**File Code:** 1920**Date:** May 27, 2015**Route To:****Subject:** Zephyr Cove Resort Access Path **Letter to file for Access Trail Modification in the Zephyr Cove Stables Upgrade Project**

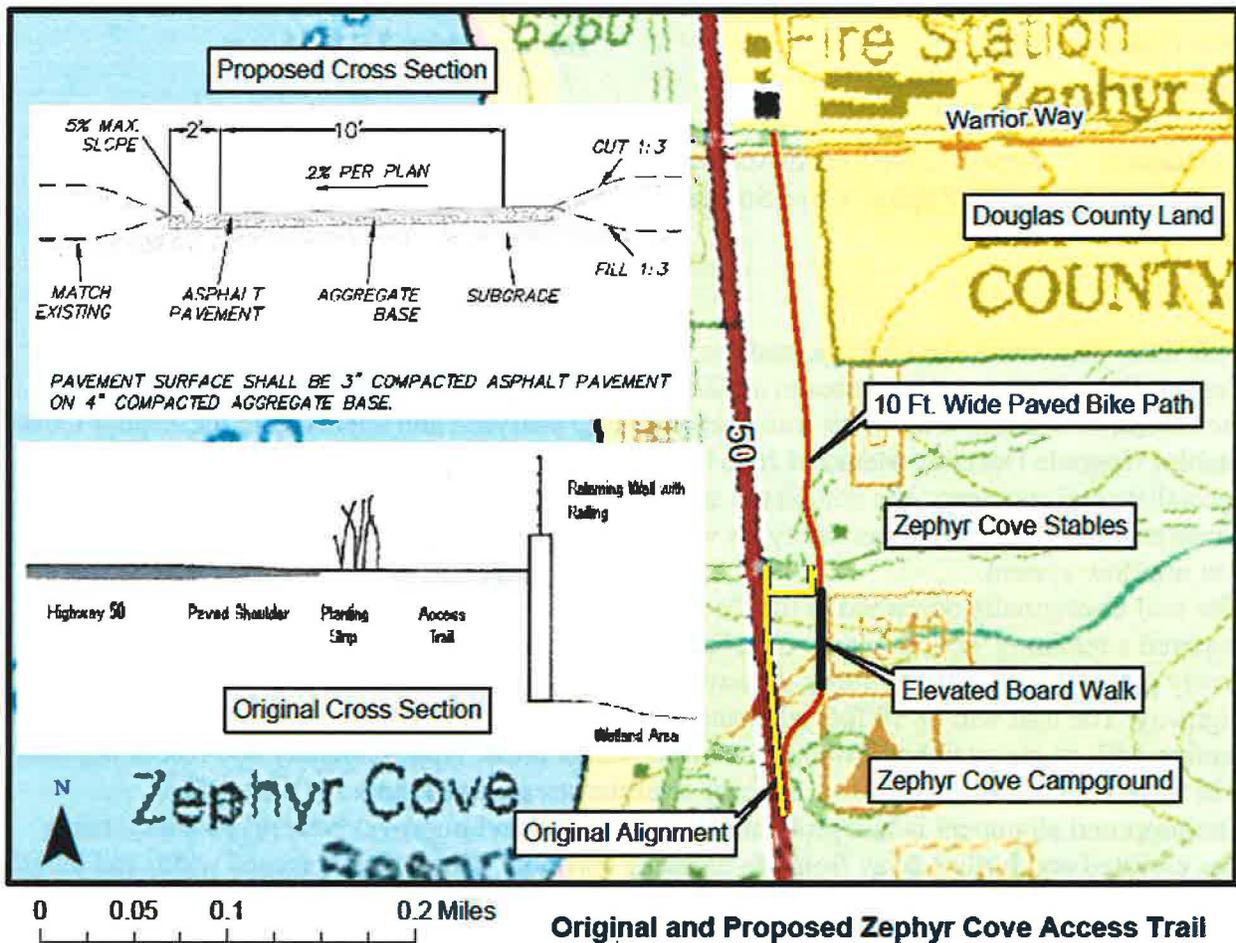
This letter documents the changes made to the alignment and design of the access trail from the Zephyr Cove Resort camping area to the Zephyr Cove Stables, as well as its extension north of the stables to Warrior Way. This trail was originally analyzed and approved in the Zephyr Cove Stables Upgrade Decision Memo of June 9th, 2011. A more detailed review by resource specialists and engineers was completed and changes are proposed in order to improve constructability and pedestrian safety, as well as minimize the impact to the stream, marsh, and wet meadow system.

The trail as originally described in the Decision Memo was located along Highway 50 and required a retaining wall, in places over five feet high, as well as a large crossing structure. The newly proposed alignment follows the natural contours of the land about 150 feet east of the highway. The trail will be 10 feet wide and will utilize a standard asphalt and aggregate cross section with an elevated boardwalk structure in wetter areas. Approximately 300 feet of the trail will be boardwalk, elevated 10 – 18 inches over the stream and marsh.

The proposed alignment is less problematic to construct and improves pedestrian safety, being less elevated and further away from the highway corridor. Due to the increased width and length of the proposed alignment, the permanent disturbance in dry areas will be greater than that of the original access trail. However, the permanent disturbance within wet areas will be significantly decreased when compared to the original alignment. Within the wet meadow system, the original route would have created approximately 3000 square feet of permanent disturbance between the edge of Highway 50 and the retaining wall. The proposed alignment will create less than 200 square feet of permanent disturbance within the wet meadow system in the form of boardwalk support piles and will allow for unimpeded flow and wildlife passage. The temporary construction disturbance within the wet meadow system is approximately the same for the proposed alignment and the alignment along the highway.
